# Featherland Park

## Town of Sudbury ADA Transition Plan

December 2020

Institute for Human Centered Design

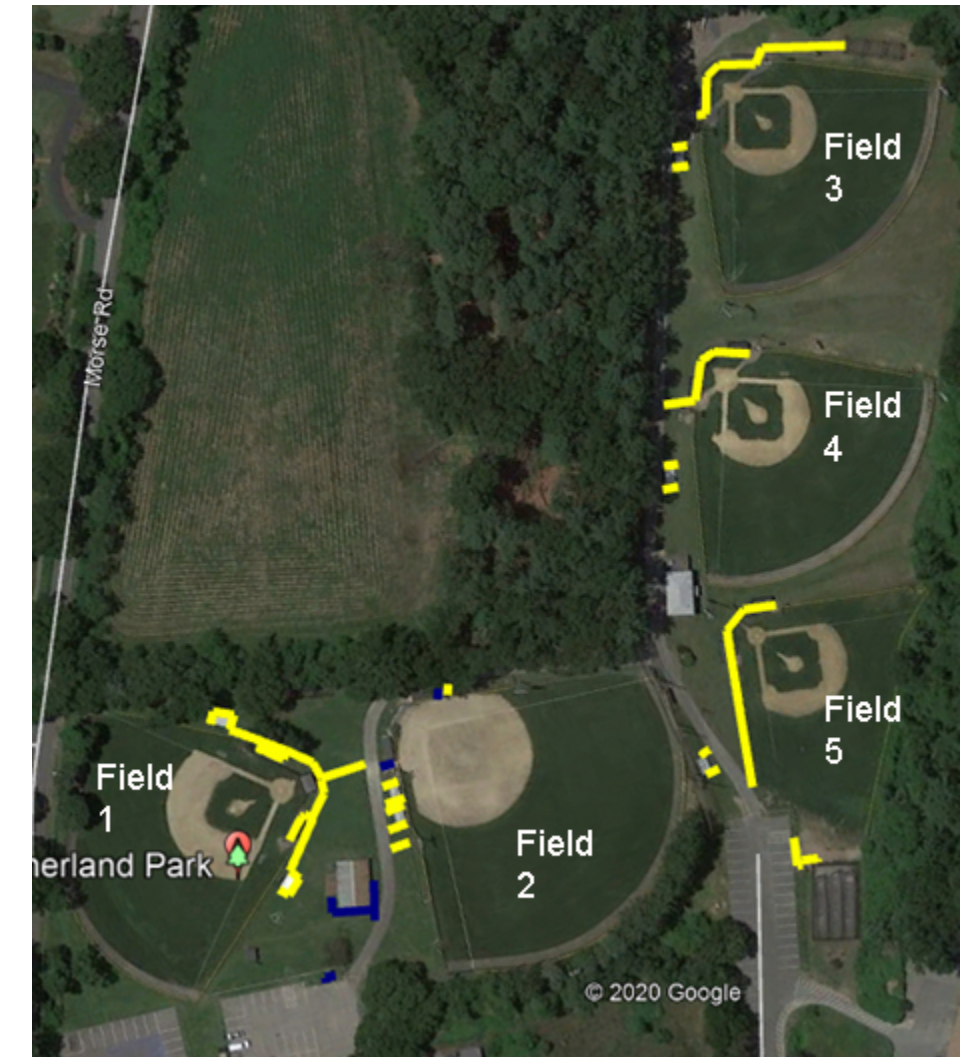
- Recommend providing clear floor space of 36" wide minimum by 48" deep alongside one bench so that a wheelchair user can sit alongside someone sitting on the bench. See the following diagram:

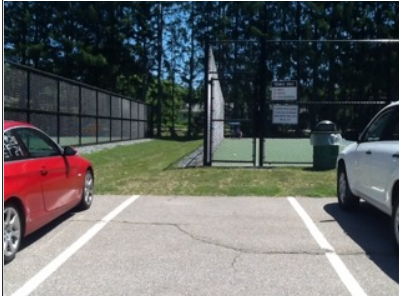
**Note:** The following graphics illustrate placement of accessible spaces alongside bleachers. Space for wheelchair users should be positioned so that a wheelchair user can sit shoulder to shoulder next to a person seated in the bleachers.

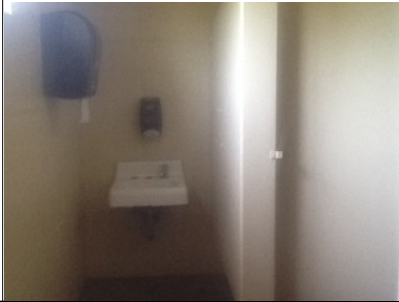
**Note:** The following image uses lines to show the approximate suggested location of accessible routes that need to be provided to amenities in Featherland Park. Yellow lines represent stone dust walkways and blue lines represent asphalt walkways.
